# SERVICE BULLETIN

75-6  
May 2, 1975

SUBJECT: FRONT FORKS  
Affected Models: GT380M, GT550M and GT750M  
Effective Engine No.:  
Reference:

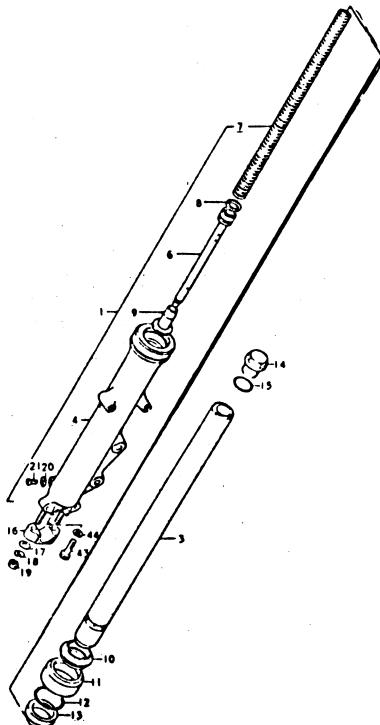
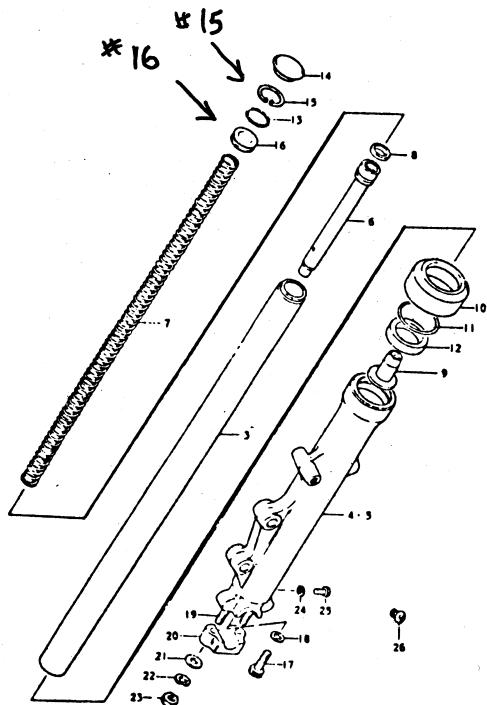
The 1975 GT series triples have slightly different front forks from those used on earlier models.

The most noticeable difference is that there is no stanchion tube cap bolt, the spring being secured instead by a machined plug (#16) held in place by a circlip (#15). Care should be taken when changing the fork oil in these units that the circlip be reinstalled properly and that it be replaced should it become bent or twisted whilst being removed. The correct oil levels for the 74 and 75 front fork assemblies can be found in bulletins #74-6 and 74-13.
